**Re: Peer Review of Revised Stationary Noise Assessment and Response Letter
507-515 1000 Islands Parkway
Lansdowne, Ontario
VCL File: 123-0297**

We have completed our review of the revised “Stationary Noise Assessment, 507-515 1000 Islands Parkway, Lansdowne, Ontario” and the accompanying cover letter, prepared by Gradient Wind, dated October 31, 2023, in response to our letter dated October 6, 2023.

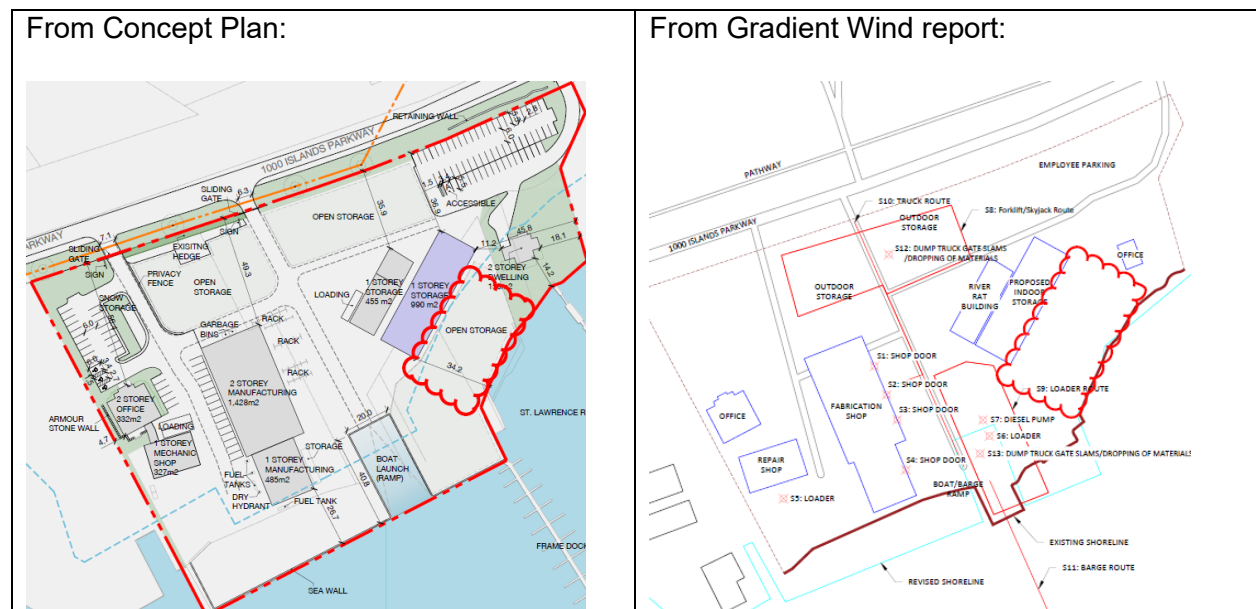
Our original comment stated, “With the exception of a loader moving near the boat launch ramp, the model does not appear to include any noise sources associated with moving goods to/from the east open storage area. Why is activity across the whole east open storage area not modelled?”

In the revised report, the model still does not show any activity in the majority of the east open storage area, nor are any additional details provided regarding activities in this area. It is noted that there are dwellings on the north side of 1000 Islands Parkway which may be impacted by activities in this area. The model should include the activities in the eastern part of the storage area to the east side of the boat launch ramp. The location in question is marked in the figure below.

Activities on the east side of the loading ramp were taken into account by represented noise sources, S6, S7, and S9. The sound power level of these sources was based on on-site measurements (P4). The noise of moving products around the Open North area is represented by S8 (Forklift and Skyjack), which represents the movement of the equipment around the perimeter of the storage area. The far east side of the site is reserved for employee parking.
